Reference No.	Council RFI Concern	Applicant Response
<b>1</b>	<b>PLANNING MATTERS</b>	
1.1	Interface with adjoining lands and road connections	
1.1.1	<p>The earthworks proposed are up to 3 metres maximum adjoining Western Sydney University (WSU) and Lot 1 Water Street to facilitate the east-west collector road &amp; road 12 and the industrial lots. There is concern regarding the level differences between the proposed works and existing adjoining lots and how the road connection will be pursued in the future. You are therefore requested to provide detailed sections at these interfaces showing proposed levels and existing levels of the adjoining lots (where future road connection is required) for review.</p>	<p>The wall heights are a function of the drainage constraints associated with Road 11 (the East West Road). At Chainage 875, the RL of this Road is set by the outlet invert level, pipe sizes and pipe cover associated with Basin C. Between this Chainage (875) and Chainage 532.354 (where Road 12 intersects Road 11, the grade of the Road is 0.7% - except for a Vertical curve near Chainage 875). Road 12 is 1% across its entire length, except for the sag curve where the Road meets th

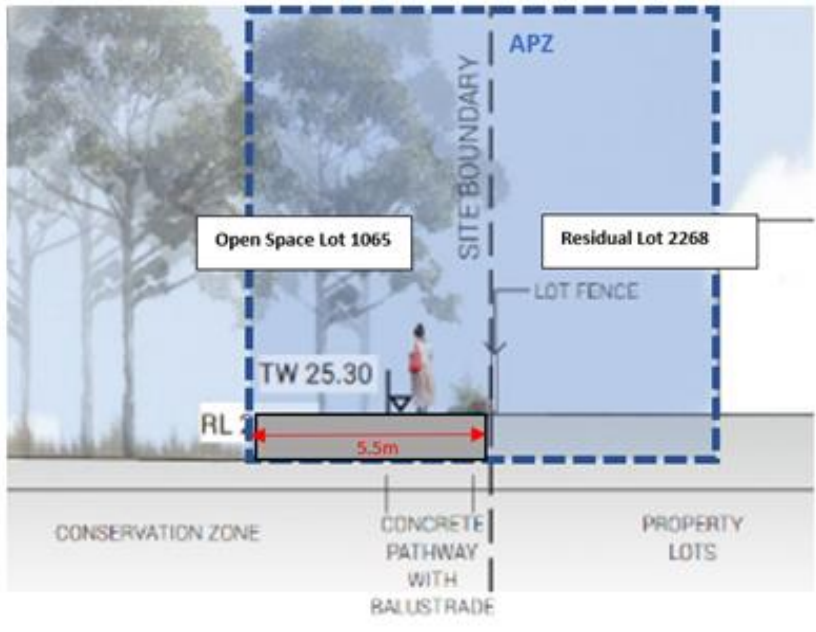
1.2.2	The elevated landform of these residential residue lots exacerbates a poor visual outcome from the public domain which a 3.5m landscape buffer can only ameliorate so much of. Essentially, the raising of these lots to provide a better	The revised plans include the lowering the landform so that the individual benches are at grade with Road 01. At Road 11 (the East-West Road), the lots will sit up to 0.6m higher than the road level. This level difference is managed through the landscape batter. At 3m wide, this will have a maximum grade of 1:5. Importantly, the need for a

Reference No.	Council RFI Concern	Applicant Response
	residential amenity is a private problem that is relying on the public domain to heavily offset. You are therefore requested to lower the final landform of these lots to a more conventional level/street level for further review.	<p>retaining wall at the rear of the residue lots has been removed from all lots apart from Residue Lot 1252, where a small section of wall is required to ensure the batters remain at a reasonable grade. This retaining wall is greatly reduced and only applies to this portion of the E/W Road (see diagram in <b>Attachment T</b>).</p> <p>Note that it is not feasible to lower the lots any further as they need to sit at least at grade with Road 01 for runoff to be captured by the Eastern OSD/bioretention basin.</p> <p>To provide Council with assurance of the outcome – there is an existing Development Application currently under assessment by Council for integrated subdivision and housing over proposed residue lots 1252, 1263, 2046, 2048 and 2212 (DA20/0200). This DA includes proposed earthworks to bench the future lots to facilitate the delivery of the associated dwellings. Please find attached <b>Attachment I</b> sketches in section illustrating how the proposed levels and the resultant subdivision and housing DA under DA20/0200 intend to be delivered.</p>
